## **Lower Rattlesnake Neighborhood Council Leadership Team Meeting Minutes**

To: City of Missoula, Montana Department of Transportation  
From: Lower Rattlesnake Transportation Committee, Leadership Team and  
General Neighborhood Council  
Re: Roundabout design for Orange/I-90 and Van Buren/I-90

# Van Buren I-90 Interchange: Roundabout A Good Choice, Yet 3 Main Safety Issues Need Addressing; From: MIST, 2-12-13

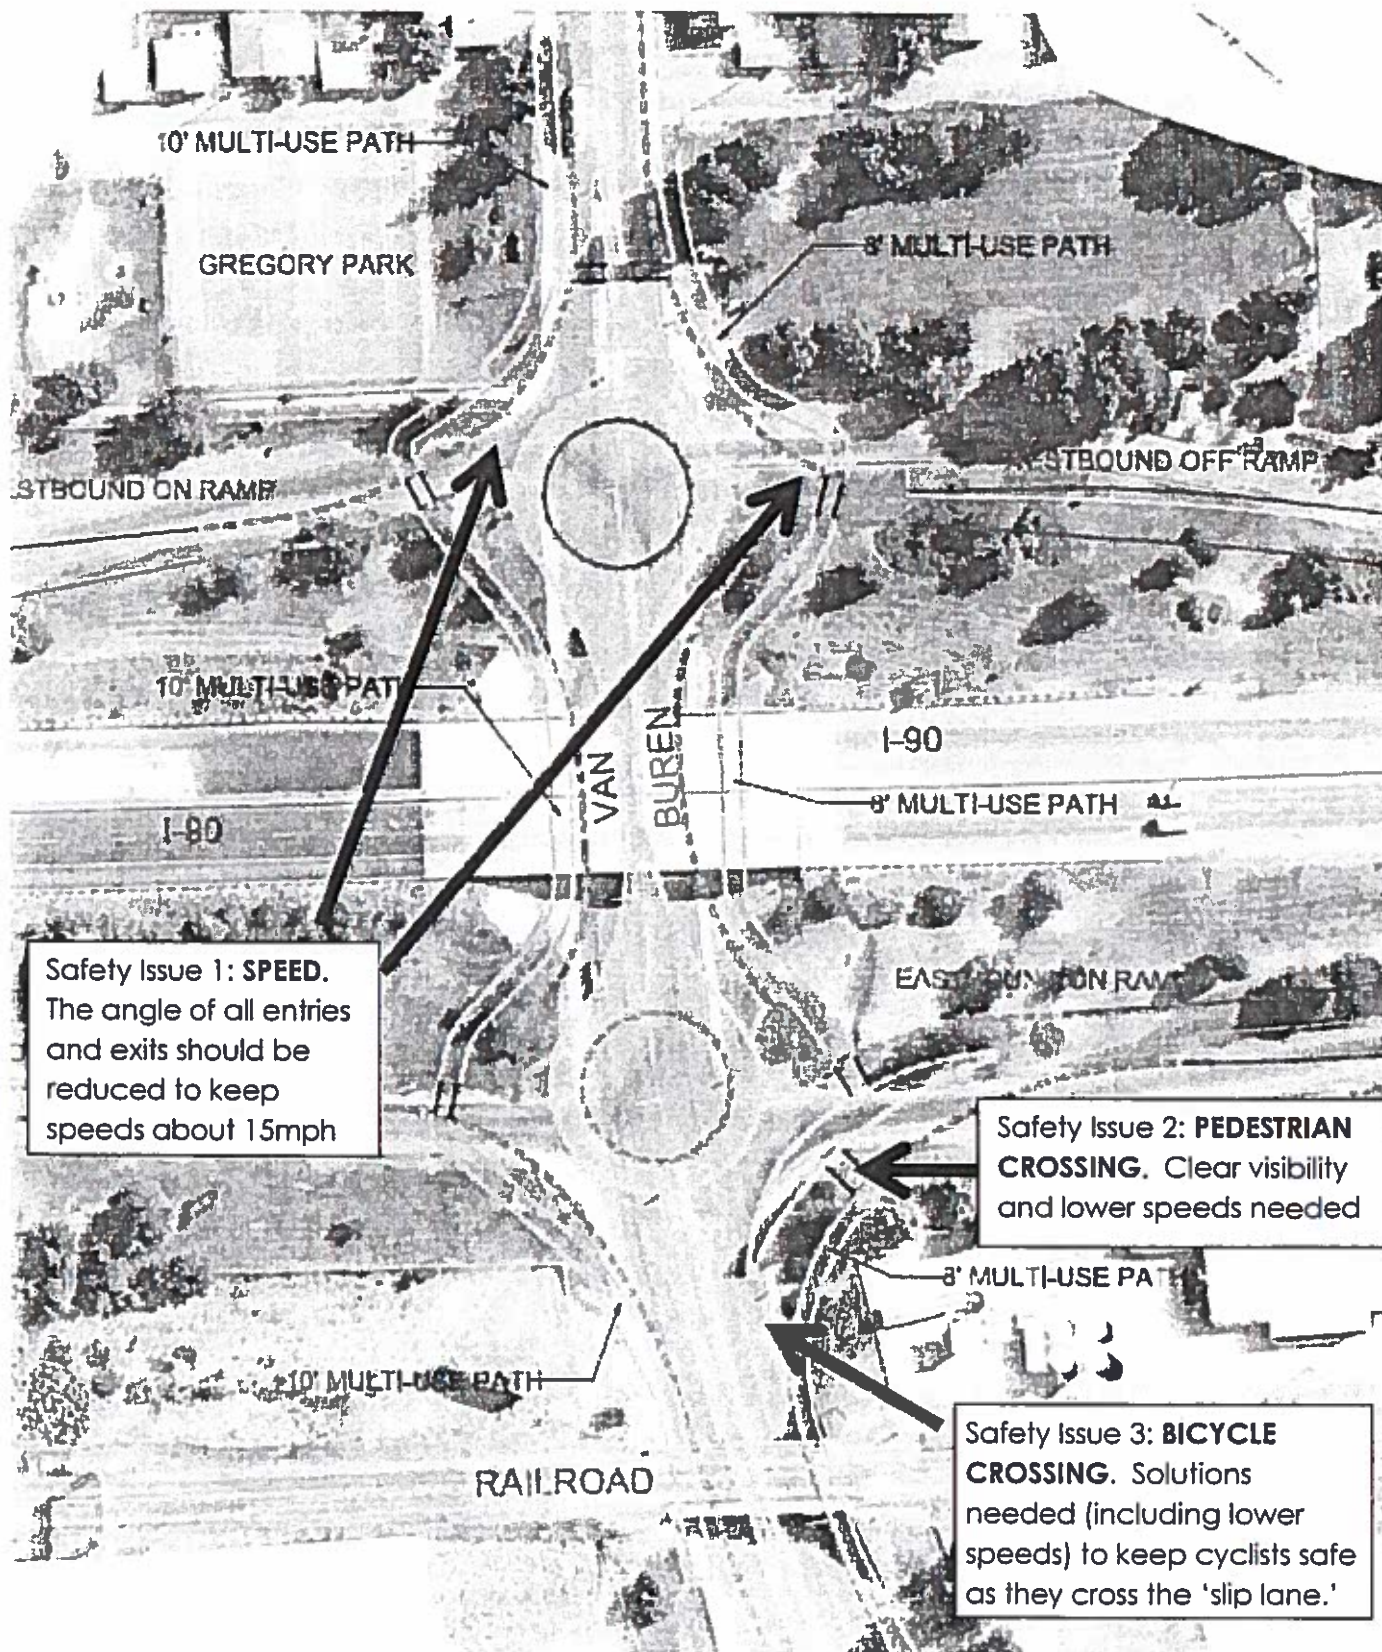
The 3 primary concerns with regards to the Van Buren Roundabouts are excessive motor vehicle speed, the pedestrian crossing of the 'slip lane' that goes onto I-90 and the bicycle crossing of that same slip lane. These 3 concerns are illustrated on the back of this letter, as shown by the Missoula Institute for Sustainable Transportation.

With regards to the upcoming roundabout at Orange/I-90, the primary concern is, again, the excessive speed that can be obtained by motorists coming off the Interstate. Excessive speed is a leading factor in crashes and also a leading factor in perceived safety and comfort, especially for those on foot or on bike.

Missoula is a leading city for making walking and bicycling both safe and enjoyable, and we therefore request that the City and State modify the roundabout design to better accommodate these modes of transportation.
